Water Right Conditions Tracking Slip

FILE # # G-17887

PUBLIC INTEREST REVIEW FOR GROUNDWATER APPLICATIONS

A. GENERAL INFORMATION: Applicant's Name: Hillsboro School District 1J County: Washington

Water Levels in Nearby Basalt Wells

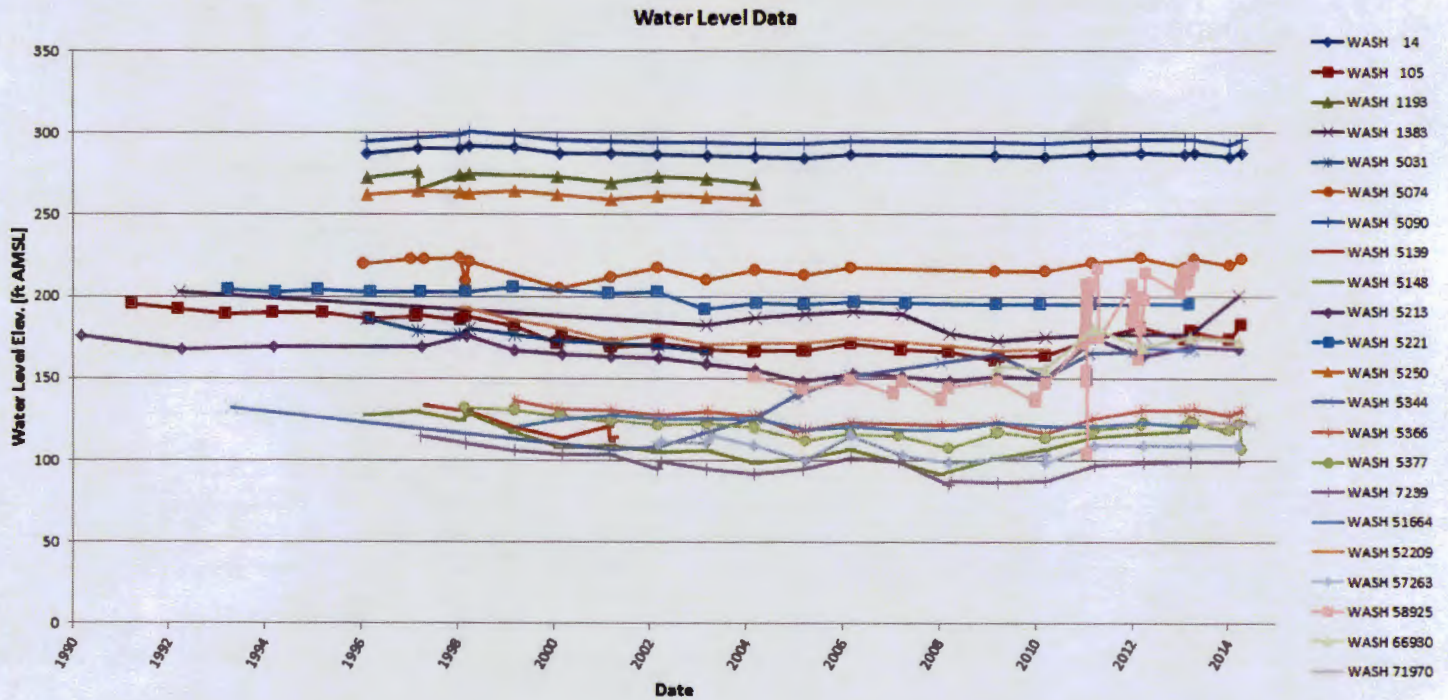
B3. **Groundwater availability remarks:** The applicant's well encountered mostly fine-grained sediments from 0-336 feet and Columbia River Basalt from 336-555 feet. The well is sealed to 348 and open to several water-bearing zones in the basalt. Some long-term instability has previously been noted in the basalt aquifer system in this area but the declines appear to be limited to wells with hydraulic heads from 150-200 feet (see attached plot). Several recent groundwater applications have been denied on this basis and one aquifer storage and recovery license was issued in order to prevent new uses from causing additional declines (ASR LL 017, and associated well WASH 58925). However, the applicant's well falls into a group of wells with lower heads that range from 80-140 feet. This latter group shows relatively stable water-levels from the mid-1990s through 2014. This suggests that these two groups of wells produce from different basalt aquifers in the basalt column. Stable water levels in the lower head group of wells suggest that this portion of the basalt aquifer system is not over appropriated and can sustain some additional development.
